In the Matter of)
)
AMERGEN ENERGY COMPANY, LLC)
)
(License Renewal for the Oyster Creek)
Nuclear Generating Station))

NUCLEAR INFORMATION AND RESOURCE SERVICE, JERSEY SHORE NUCLEAR
WATCH, GRANDMOTHERS, MOTHERS AND MORE FOR ENERGY SAFETY,
NEW JERSEY PUBLIC INTEREST RESEARCH GROUP, NEW JERSEY SIERRA
CLUB AND NEW JERSEY ENVIRONMENTAL FEDERATION
(COLLECTIVELY "CITIZENS")
REPLY TO NRC STAFF AND AMERGEN RESPONSES TO
COMMISSION ORDER DATED MAY 28, 2008

Subject: Discussion of Sensitivity Analyses Proposed
By NRC Staff and AmerGen

Subject: Technical Commentary on Structural Analyses, Oyster Creek Drywell Vessel

Contour Plot for Bay 13 External Corrosion 2006 Data

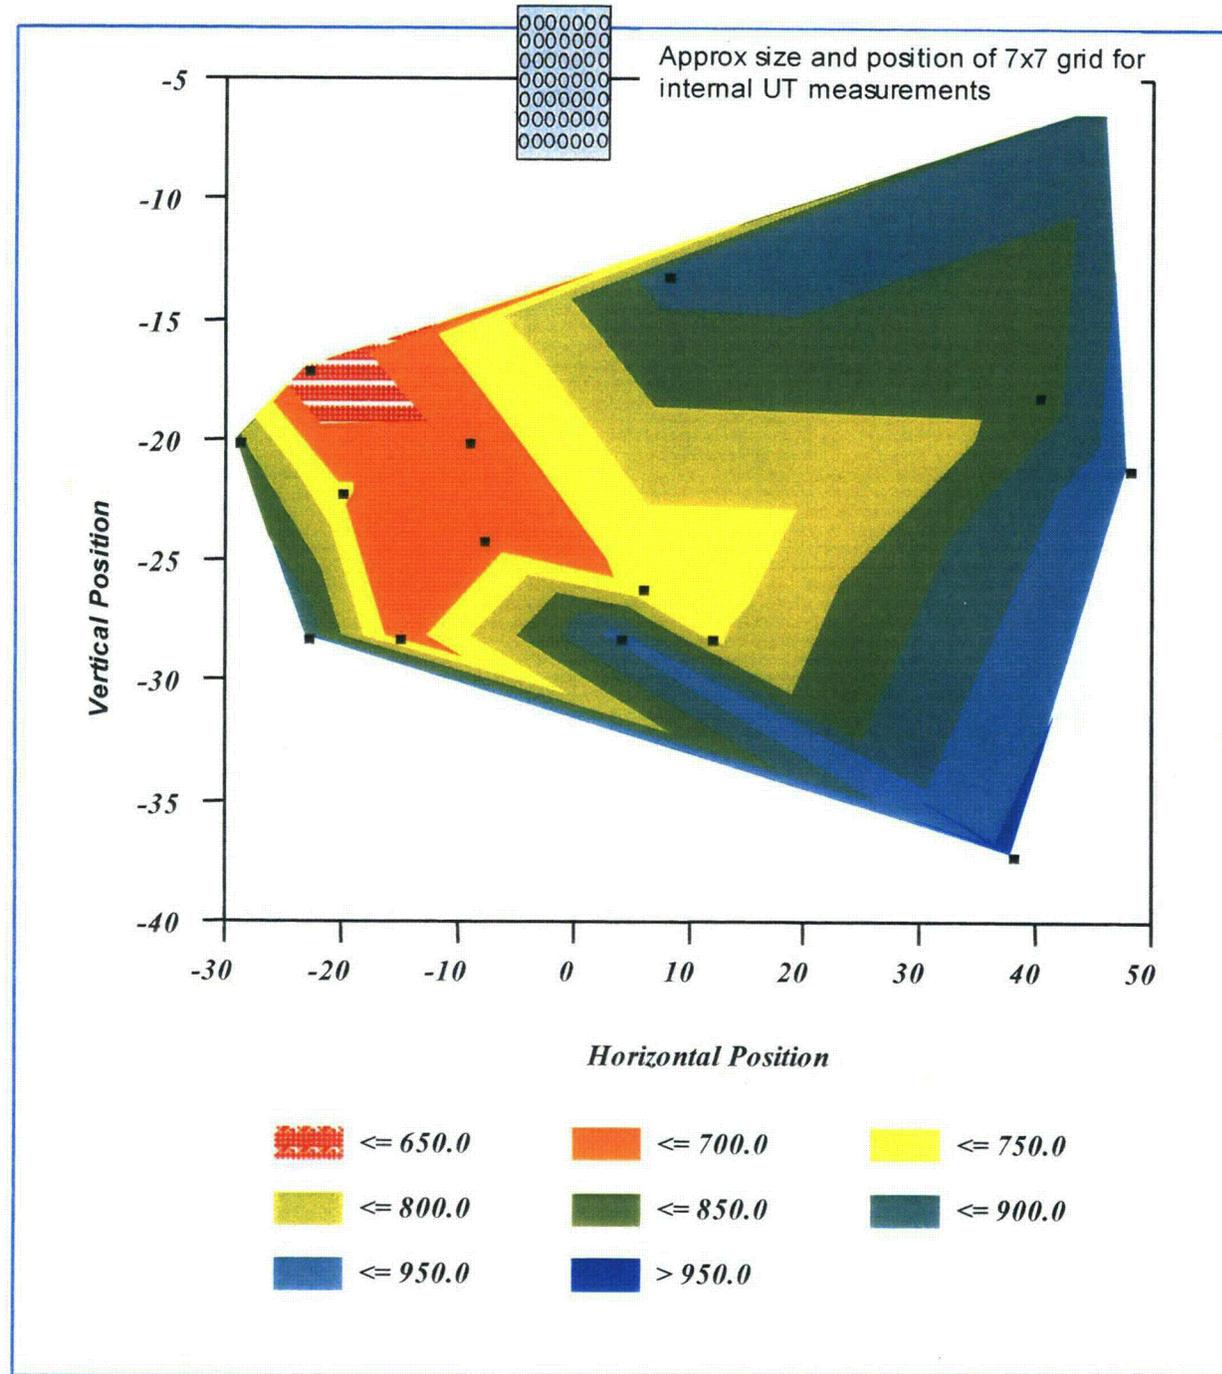
Bay 13: This is one of the most corroded bays. As Figure 9 illustrates there are sizable areas with remaining wall thickness below 700 mils, nearly 40% loss of wall thickness. The average of the external measurements is 785 mils. AmerGen chooses to use the average of the two 7x7 internal Grids which is 907 mils. However, as Fig. 11 illustrates the grid measurements are well outside the elevation where the most corrosion occurred and can therefore hardly be representative of the corrosion which occurred in this Bay.

Contour Plot for Bay 17 using 2006 data

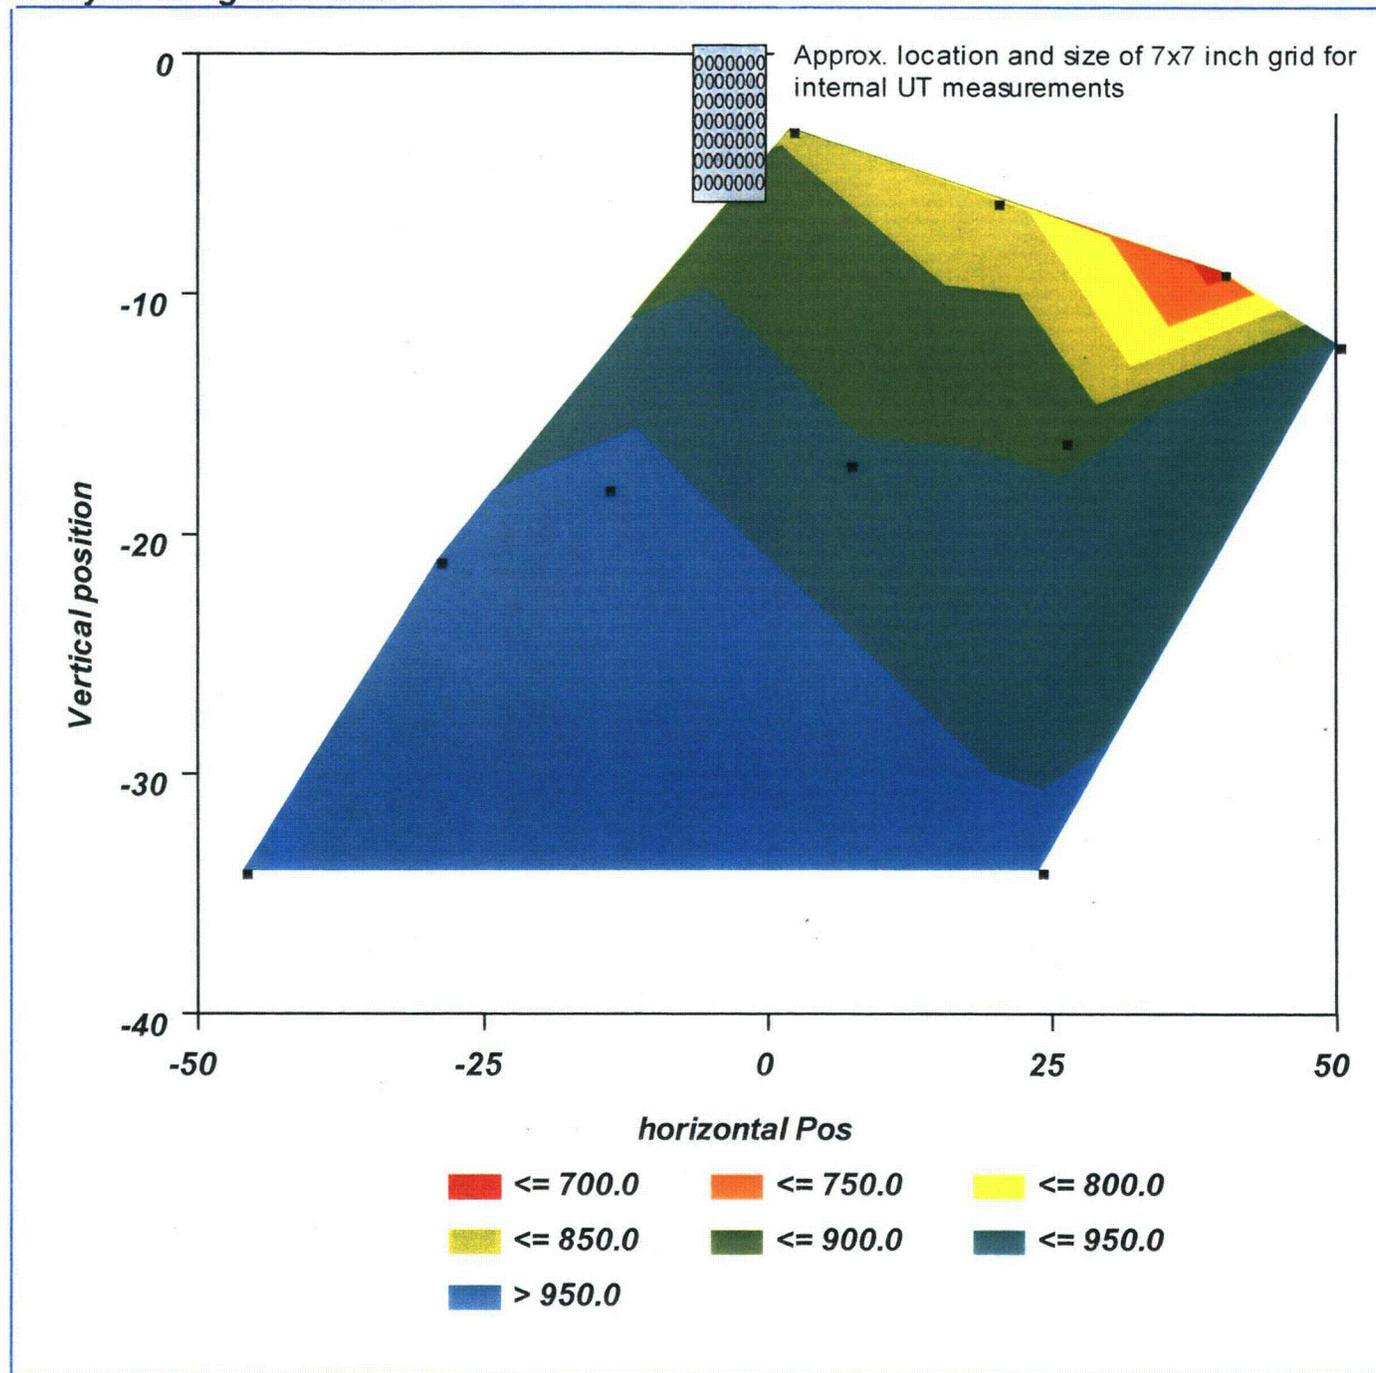
Bay 17: This Bay (Figure 11) does not appear to be badly corroded on average, however, as has happened before in other bays, the one spot, where residual wall thickness of less than 700 mils was observed, was not further investigated, leaving open the possibility that serious corrosion might indeed extend beyond that point.

Comparison of Various Thickness Measurements in Bay 17

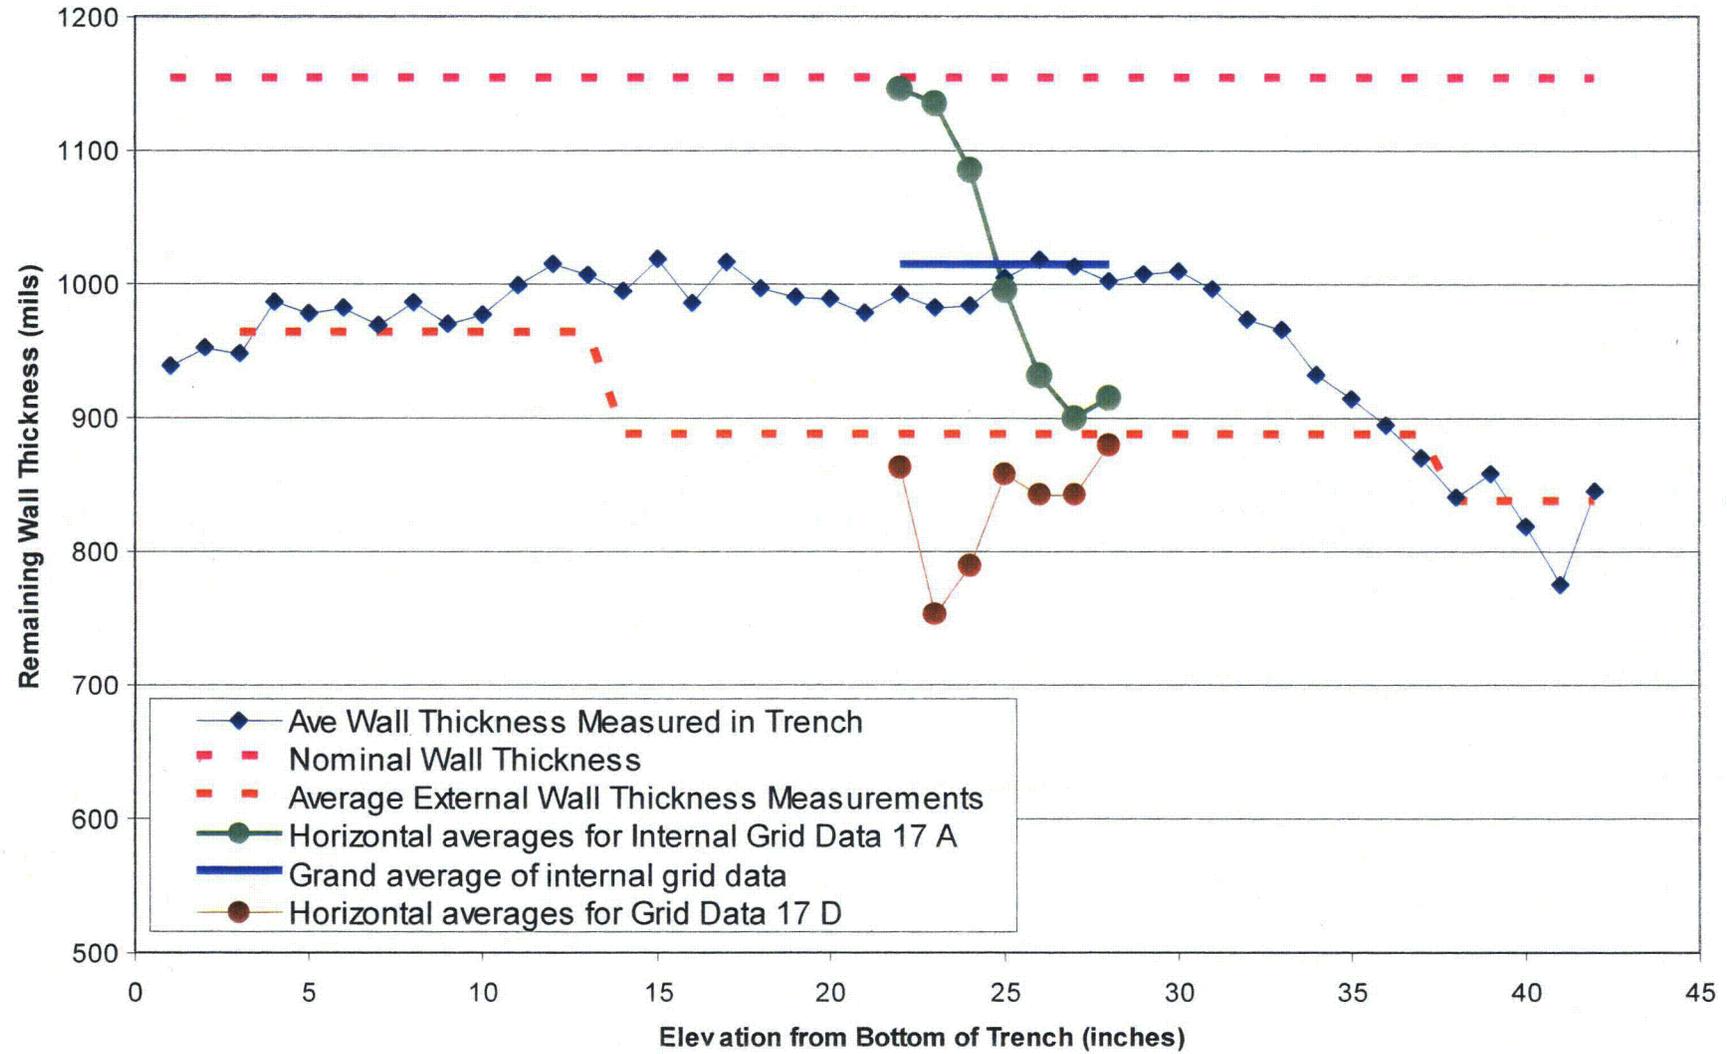
A trench had been dug in this bay from the inside of the containment vessel as well. Again, the residual wall thickness had been UT measured using a series of 7x7 inch grids stacked one on top of each other. These measurements are shown in Figure 12 in comparison to the (regular) internal 7x7 grids (see also Table 1). The trench data indicate that most of the corrosion occurred at the highest elevation from the bottom of the sandbed. In fact here the remaining wall thicknesses correspond to the results of one set of grid data. And since the top of the trench and the grids were not at the same peripheral location in this bay it is reasonable to assume that the corrosion was wide spread on the top of the sand bed, which in this case must have reached up quite high.

AmerGen uses a convoluted argument to arrive at a representative residual wall thickness for this bay of 954 mils. The actual data would suggest, however, large parts of the wall in this bay are substantially thinner and more of the order of 800 to 850 mils.

Bay 19 External 2006 UT Measurements, Minimum Values

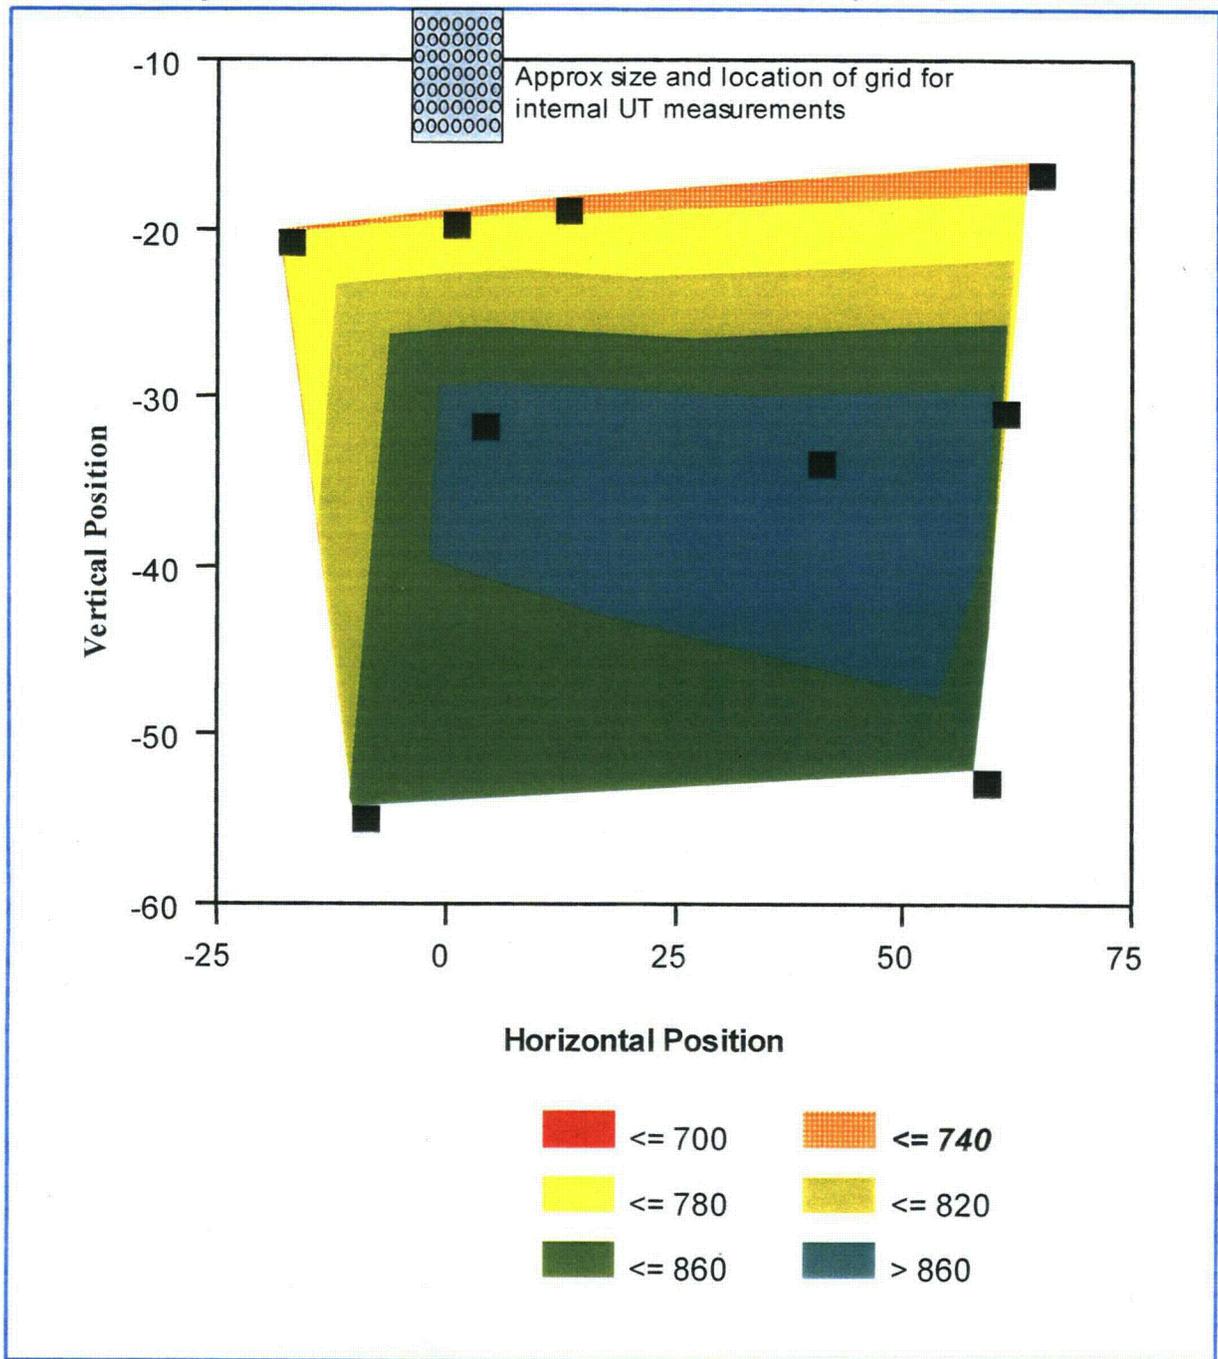
Bay 19: Figure 13 shows the data for this bay. It turns out that the most severe corrosion occurred toward the top of the sandbed. Internal and external averages appear to agree, but the fact that there is very likely an area of severe corrosion between the top of the external measurements and the bottom of the internal ones suggests that perhaps the average wall thickness chosen by AmerGen (826 mils) is somewhat too high and the average of the external measurements, 801 mils may be more appropriate.
